1926 PIKE PLACE (KITCHEN & MARKET)

SITE PLAN - BLANK

KITCHEN & MARKET - MADISON VALLEY
EXTERIOR PLANTERS - 4/1/2024

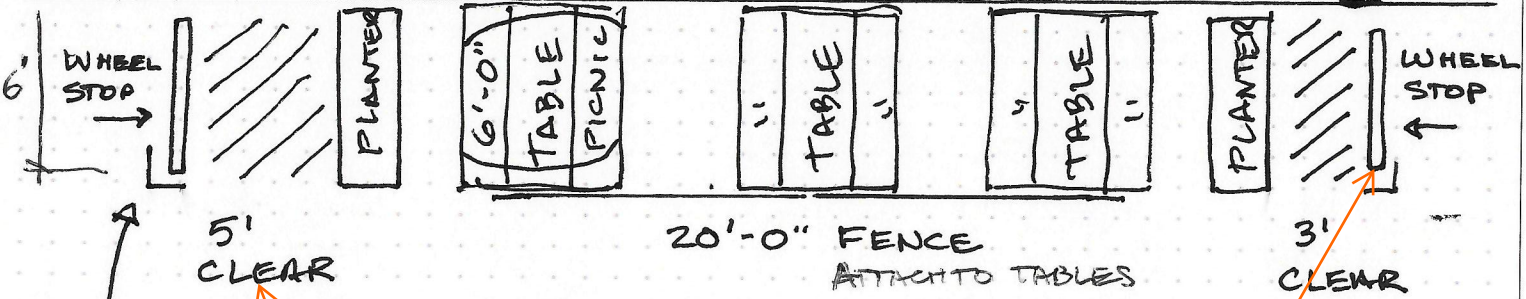
Minimum 3-ft clearance shall be maintained from existing lamp post.
If there is a wheel stop, this clearance is from the wheel stop. Otherwise this clearance is from the cafe itself.

This wheel stop only necessary if no neighboring cafe. Hellenika next door has also applied for a cafe adjacent to this one.

Reduce to 3-ft clearance
